# Phoenix Accessibility Action Plan April 2023

Figure 4 — Access around designated off-street parking spaces

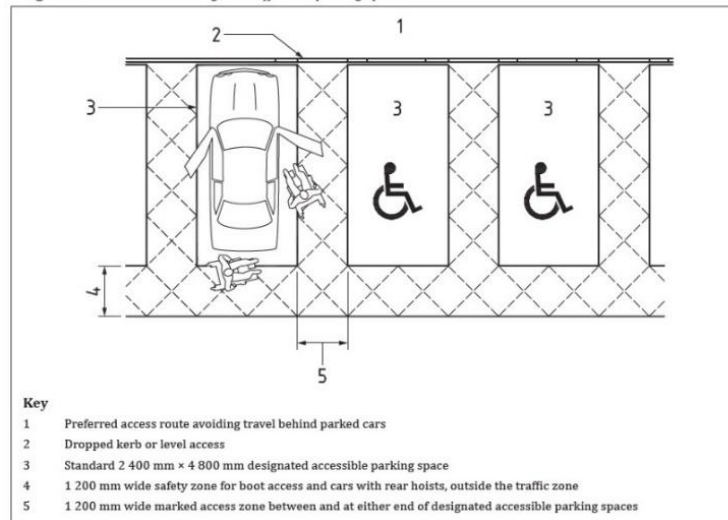
2.3	<p>The first 5 designated accessible parking should be clearly marked out at least 2.4m wide x 4.8m long plus a 1.2m side transfer zone at the side and end of the bay.</p>	<p>The accessible bay markings should provide clearly defined 1200mm transfer zones to both sides and rear and with the required access symbol.</p> <p>BS8300 recommends a sign or, if appropriate, signs should be provided at the entrance to each car park and at each change in direction to direct disabled motorists to designated parking spaces. Also, install a sign to the front of each space as shown:</p>	<b>M</b>

Figure 31 — En-suite shower room for use with a ceiling-mounted full room cover tracked hoist system for assisted use

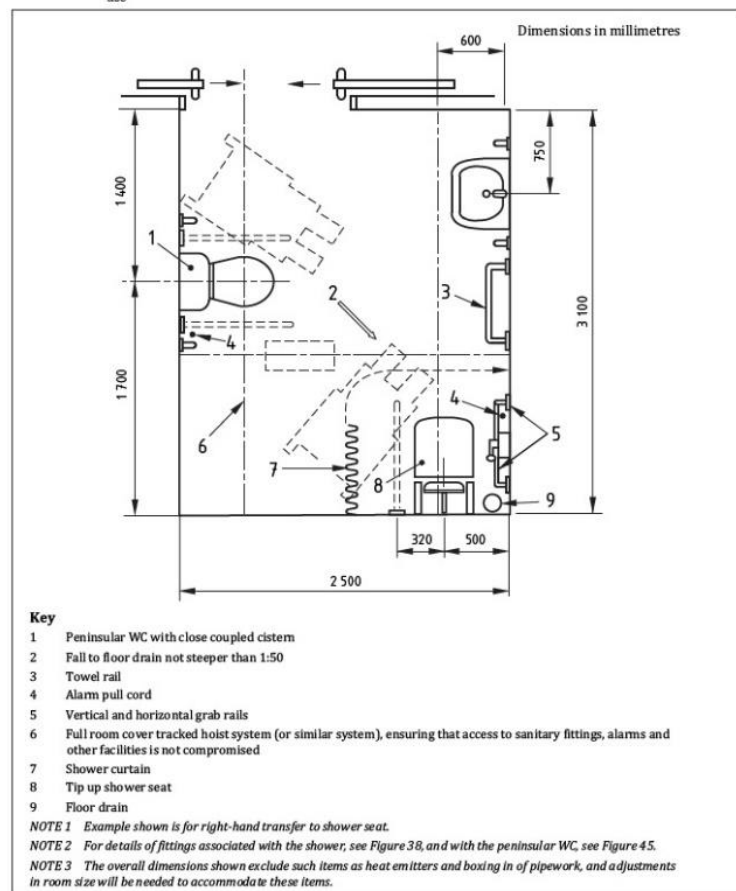
12.8	<p>Various accessible changing rooms were provided and with all having ceiling mounted hoists and some with changing beds. All had peninsular style WCs.</p> <p>Most had tip up shower seats with drop down rails to either side but none had vertical wall mounted rails. None of the sinks had wall mounted grab-rails.</p> <p>Two showers with stepped access and no grab rails were seen but as there is range of accessible facilities this would be deemed suitable to retain - but for future development consider showers with level access and grab-rails for the shower.</p> <p>Grab rails and WC seats contrasted but the sinks and WC pan did not contrast.</p> <p>A mixture of flushes were seen.</p> <p>All had lever taps for showers and sinks.</p> <p>Alarm cords for most were tied up or cut off.</p> <p>Changing areas for hydro pool - 38, 39 mirror of each other, cords tied up.</p> <p>Showers by hydro pool - 31, 32, same</p> <p>Shower and WC 56, 57, same</p> <p>Wet room/ shower 76 no sign on door cord cut</p> <p>Wet room/ shower with hoist 94 not used as shower.</p> <p>Wet room/ shower with hoist 122 (123 mirror image)</p> <p>Wet room/ shower &amp; WC with hoist 132</p>	<p>Colour contrast should be added to the fixtures and fittings within the showers, or the walls should contrast from the fittings.</p> <p>According to BS8300 - to help blind and partially sighted people identify key objects within sanitary accommodation, support rails and grab rails should contrast visually with the wall, the WC seat and cover should contrast visually with the WC pan and cistern, and sanitary fittings and accessories should contrast visually with the background against which they are seen.</p> <p>Refer to BS8300 recommendations regarding the locations of grab rails and other fittings, as appropriate, for peninsular style WC and bathroom facilities.</p> <p>Refer to recommendation for 13.11 regarding cord alarms.</p>	M/OG

Figure 47 — Urinals accessible to wheelchair users and people with ambulant mobility impairments

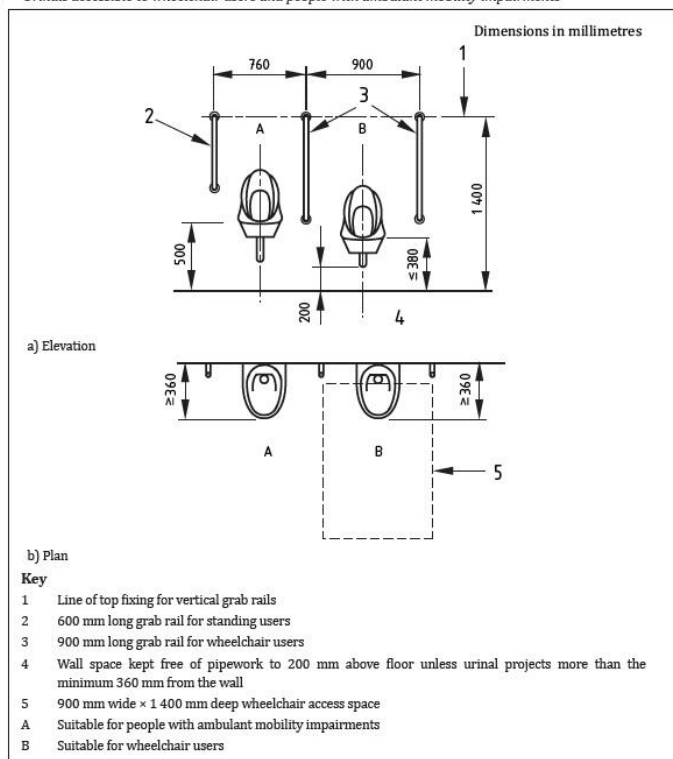
12.5	Urinals in the boys WCs contrast but do not feature grab rails to aid ambulant disabled persons.	<p>It is suggested that urinals for wheelchair users and ambulant disabled people are provided as well. The wheelchair space in front of a urinal should be level. Vertical grab rails for the benefit of a disabled person who is standing should be provided on each side of a urinal where stall privacy dividers are not fitted.</p> <p>Fittings, support rails and grab rails should contrast visually with the wall; the WC seat and cover should contrast visually with the WC pan and cistern; and sanitary fittings and accessories should contrast visually with the background against which they are seen.</p> <p>See below for suggested layout.</p>	<b>M</b>	
------	--	---	----------	--

This diagram gives general guidance on the suggested height for positioning different types of sign, determined by the intended use of the sign (all dimensions are given in millimetres)

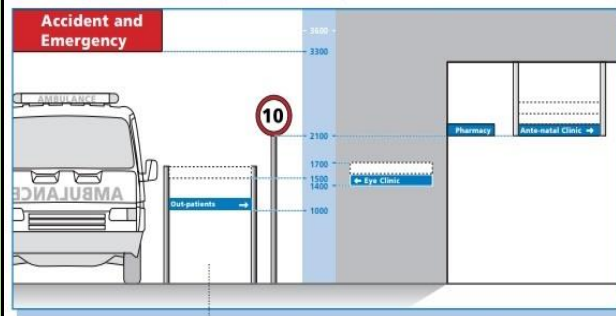
Upon entering the reception area there is a lack of suitable directory signage.

Signs and universally accepted symbols or pictograms, indicating lifting appliances, stairs, toilets, circulation routes and other parts of the building, should be provided in the reception area. The NHS Wayfinding guide and Exhibitions for All (NMS) offers good guidance regarding positioning.

Consistency of sign height and position throughout the premises is important. Signs should be placed between 1400mm and 1700mm for blind and partially sighted people when standing. For wheelchair users signs should be placed between 1000mm and 1100mm above floor level. Signs associated with control panels, e.g. lifts or door entry systems should be located between 900mm x 1200mm, to meet the needs of both wheelchair users and people standing.

Figure 50 — Work surfaces and accessories

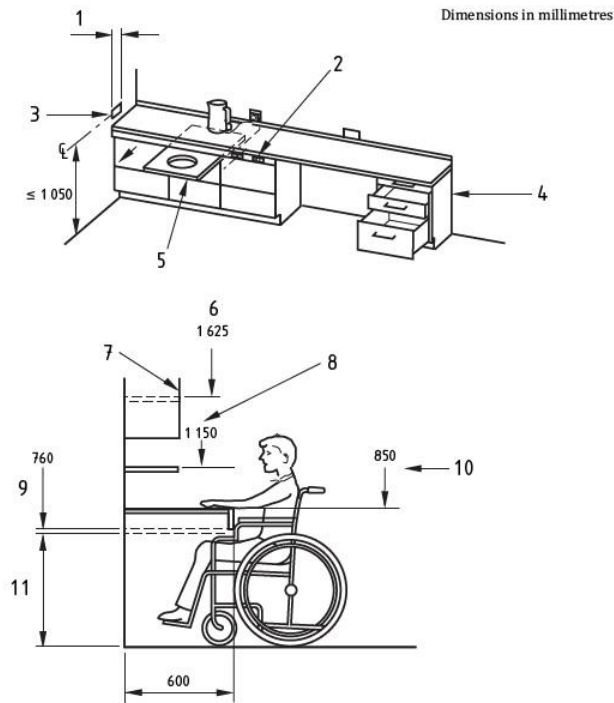
14.8	<p>A range of taps were seen and some were lever style taps. Others were turn taps.</p> <p>Classrooms had sinks with taps but not lowered counters.</p> <p>Room 86 teaching kitchen, 131 nursery kitchen have height adjustable hobs.</p> <p>Nursery has height adjustable sink in main area.</p> <p>Parents meeting room had a lower counter but not a specific style intended for use by a wheelchair user.</p>	<p>A kitchen area should have an unobstructed floor space of at least 1 500 mm × 1 500 mm between facing floor units or between floor units and a wall. Where possible, an unobstructed space or knee recess, at least 800 mm wide, should be provided to one side of kitchen appliances such as refrigerators, washing machines, freezers or ovens.</p> <p>Taps should be changed to lever style or automatic sensor taps to aid people with limited dexterity.</p> <p>The kitchenettes should include disability access, i.e., a section of work top lowered to 760mm (or 850 for a shared worksurface) with clear space underneath of minimum 700mm to allow wheelchair access; sink unit to have lever taps fitted, and utensils included.</p> <p>Refer to images.</p>	M/ST
